DEVELOPMENT APPLICATION NO: DA19/0875

URBIS RESPONSE TO PENRITH CITY COUNCIL REQUEST FOR ADDITIONAL INFORMATION – 27TH APRIL 2020

Response to RFI Relating to Visual Impacts

NEPEAN GARDENS, WALLACIA, NSW

VP B : 115 PARK ROAD - DRIVEWAY, LOOKING NNW | 3D MODEL - FULL MONUMENTAL WITH 1500MM HEADSTONE (WITH VEGETATION AT 5 YEARS)

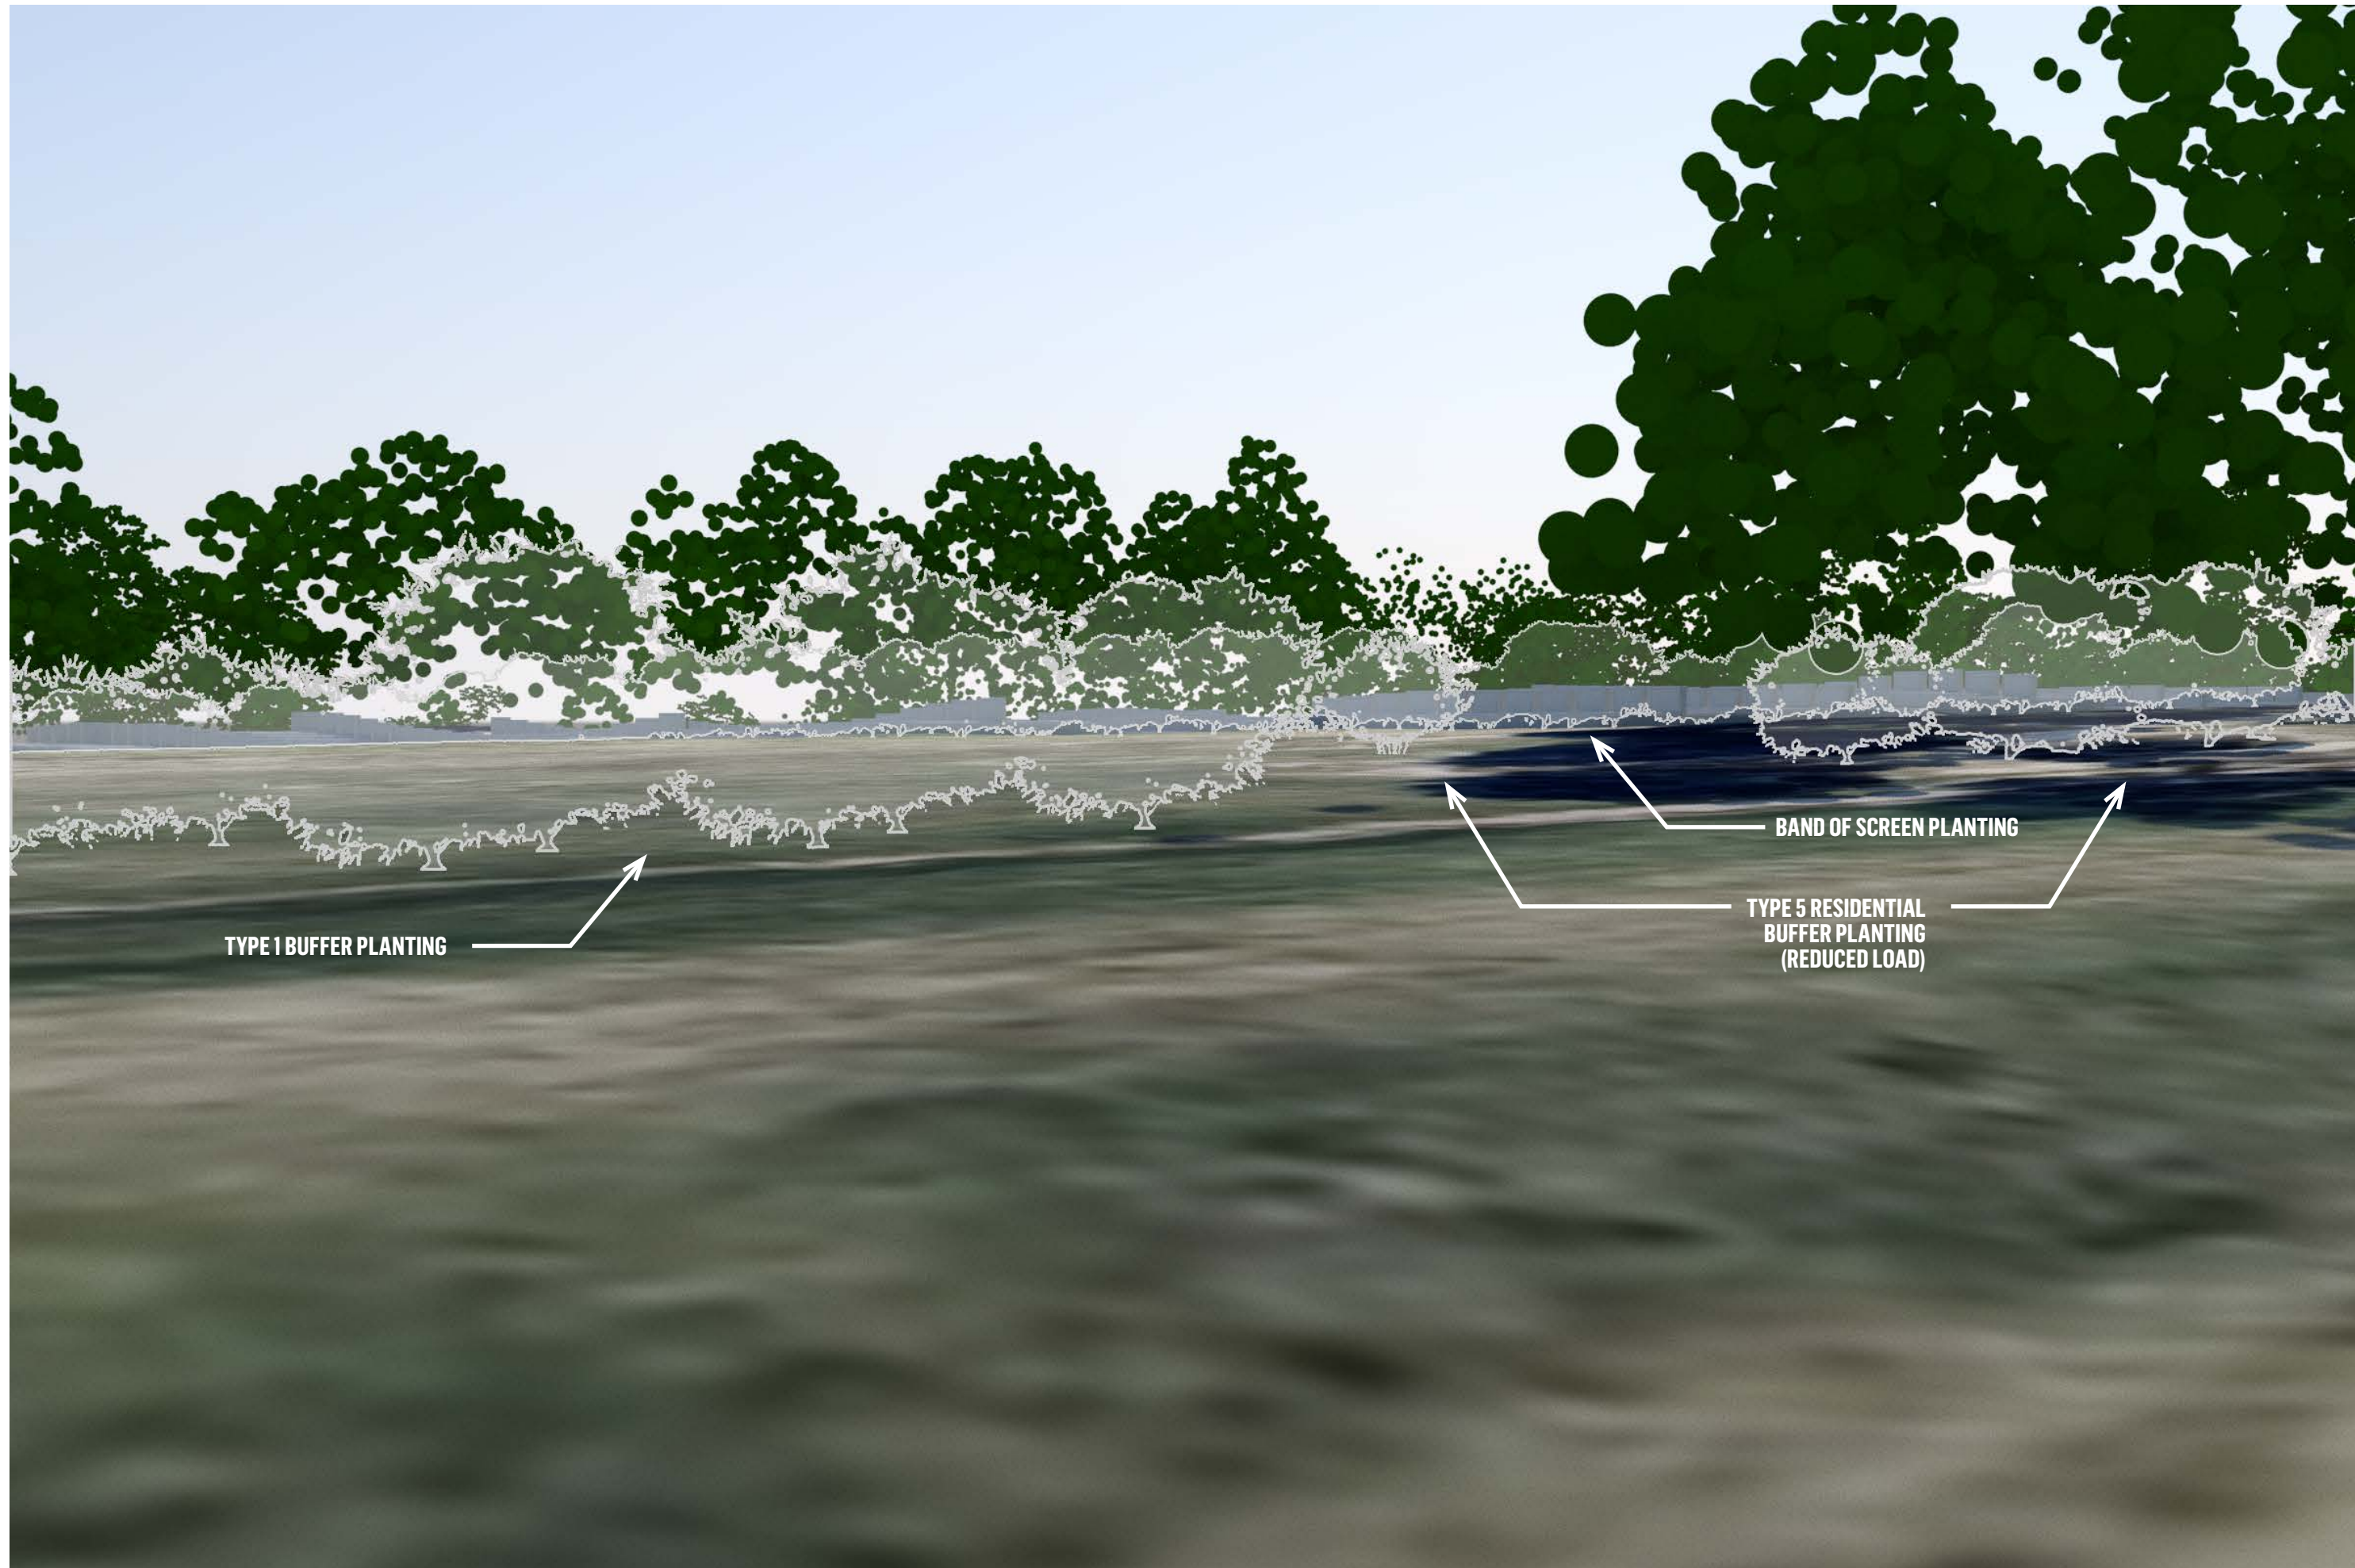
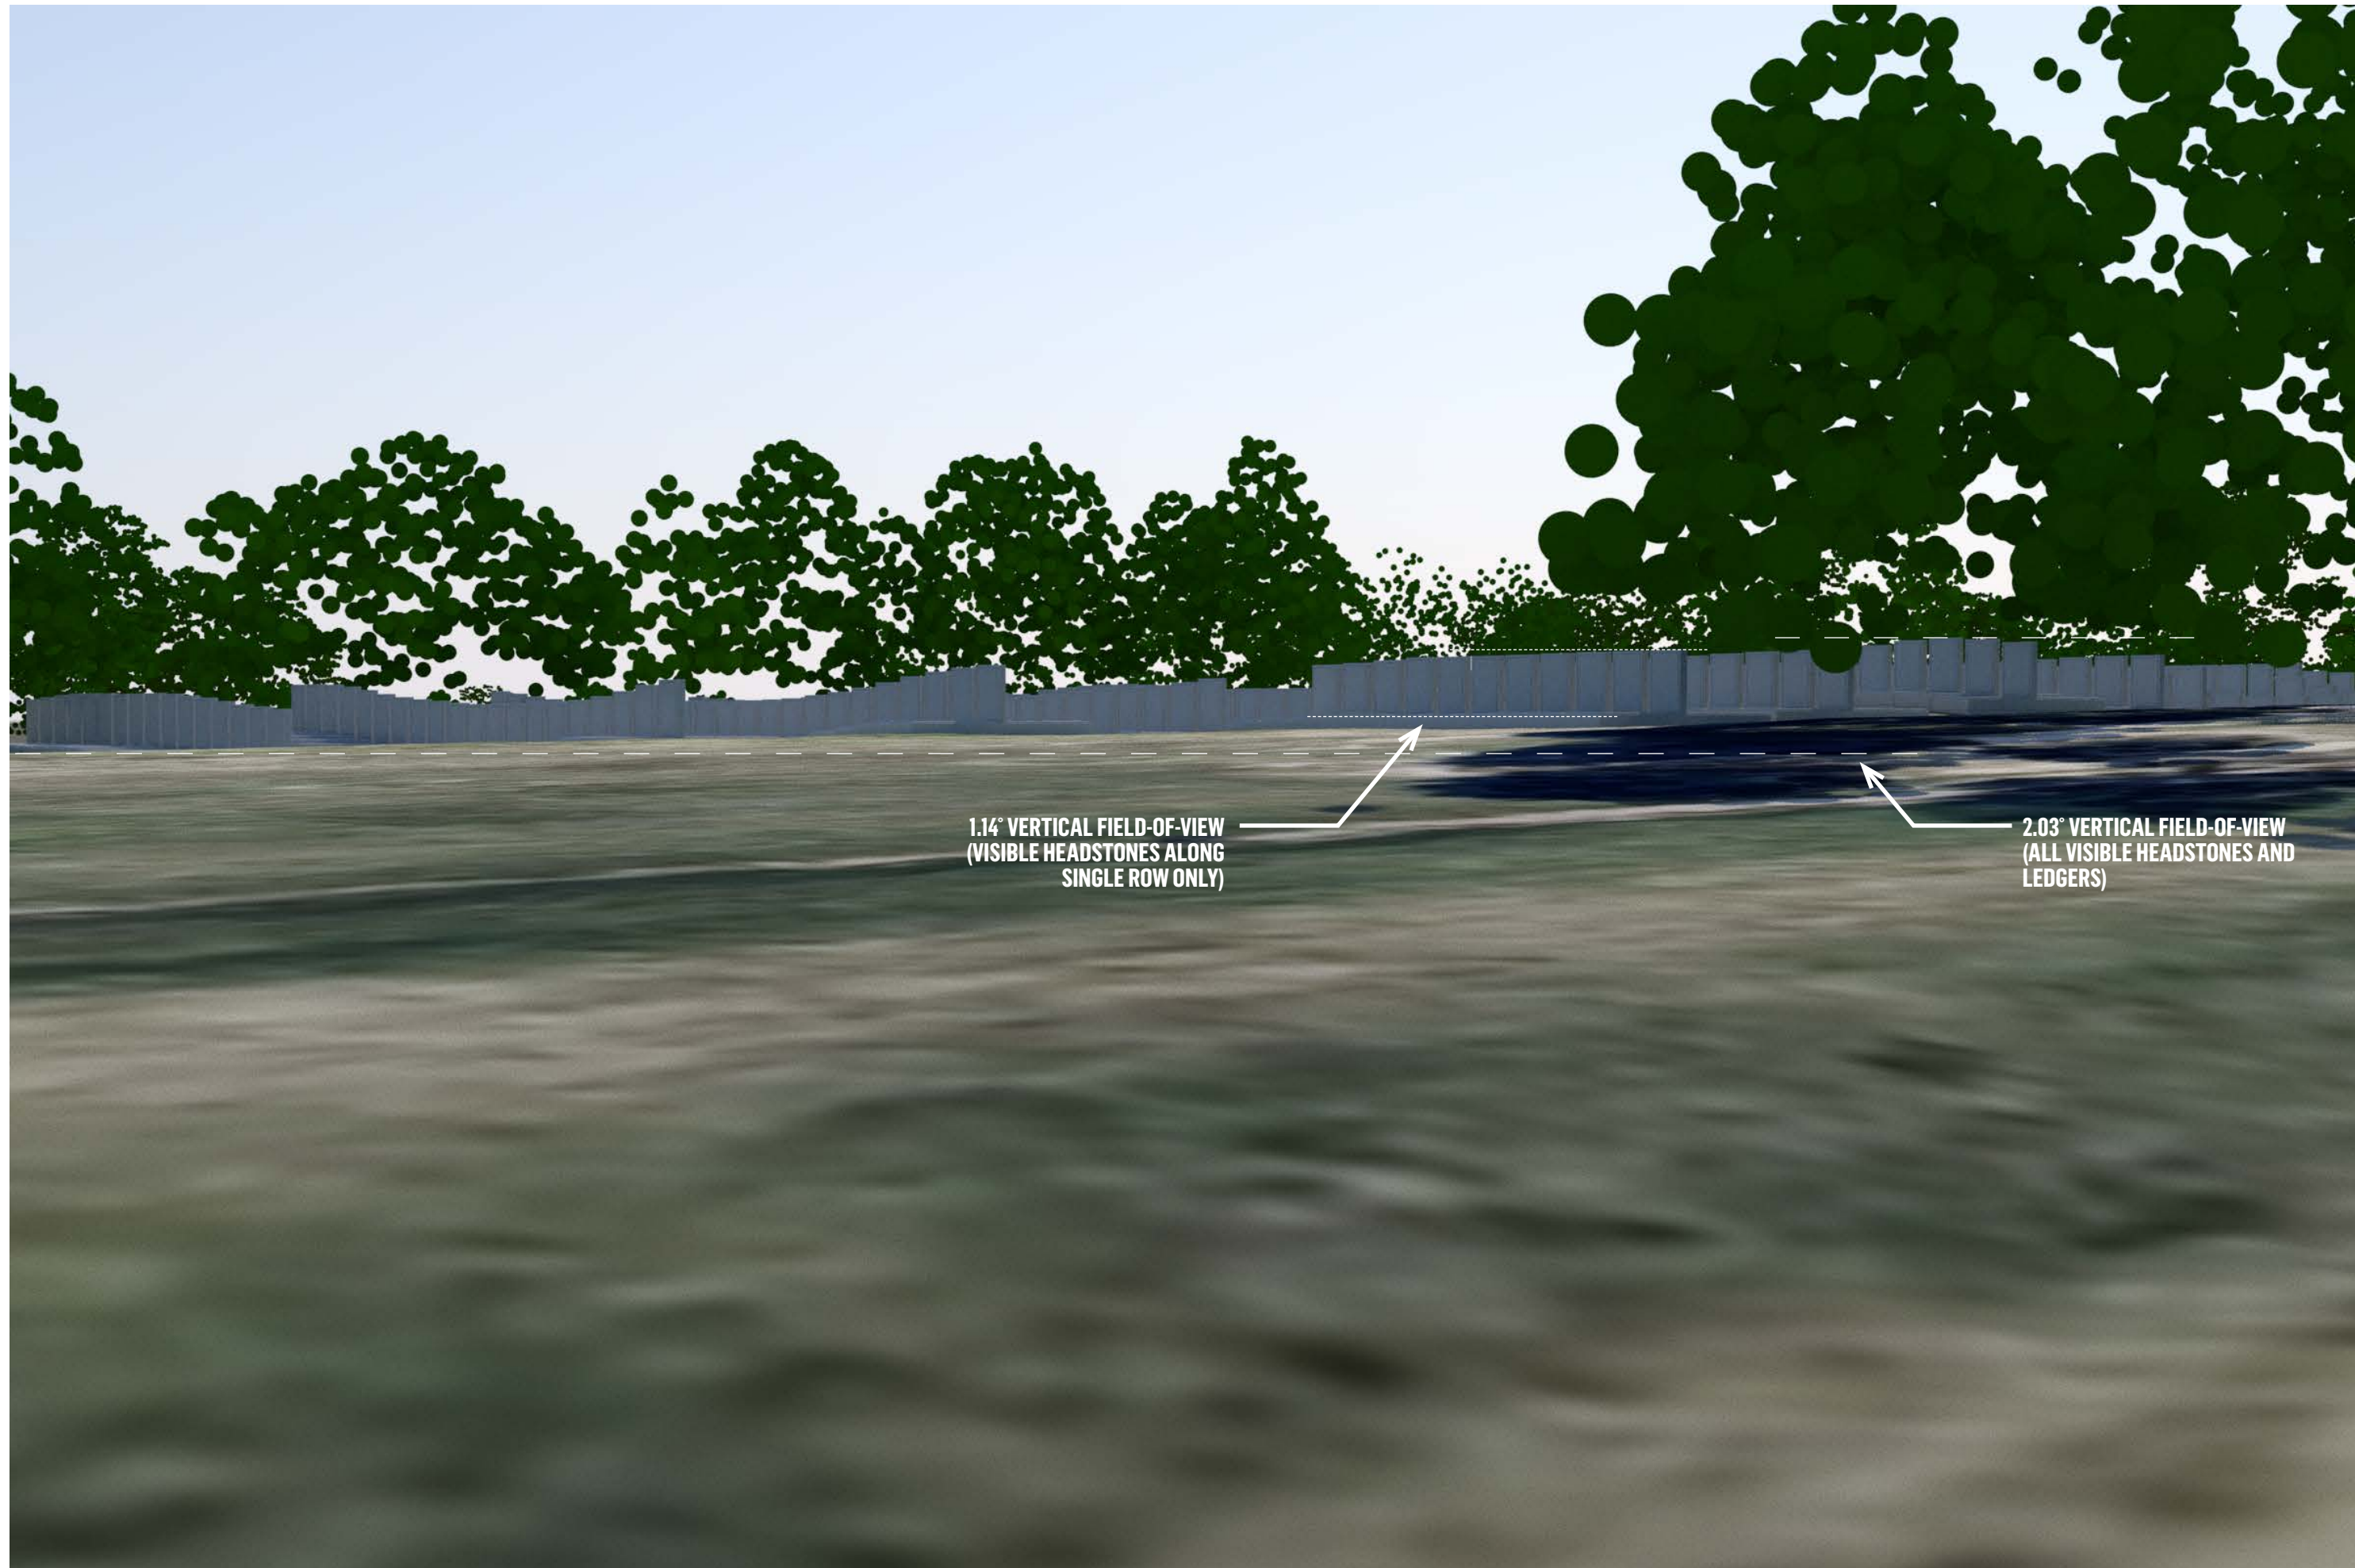
(h) The proposal for Type 3 - 1.5m high memorial head stones is likely to impact poorly on views from neighboring rural residential properties. A response is requested as to why memorial headstones should not be limited in height to 600-800mm, so as to be less visible. The impact of the proposal for Type 4 - Full monumental installations needs to be assessed and in this regard, further detail is to be provided as to the allowable dimensions and locations for this typology. A view analysis or montage may be required.

- VP A – 0.19° vs 0.52°
- VP B – 0.53° vs 1.14°
- VP C – 0.76° vs 1.23°

In all views, the buffer landscaping is highly effective at ameliorating views from surrounding areas. Given the headstones are only 1.5 m in height, buffer planting proximate to viewing location is highly effective in screening views within a relatively short period of time. Post planting, the landscape will gradually reduce views of the monuments. The computer simulations demonstrate that after 5 years, the landscaping will be of a height to effectively screen views to the tops of the monuments.
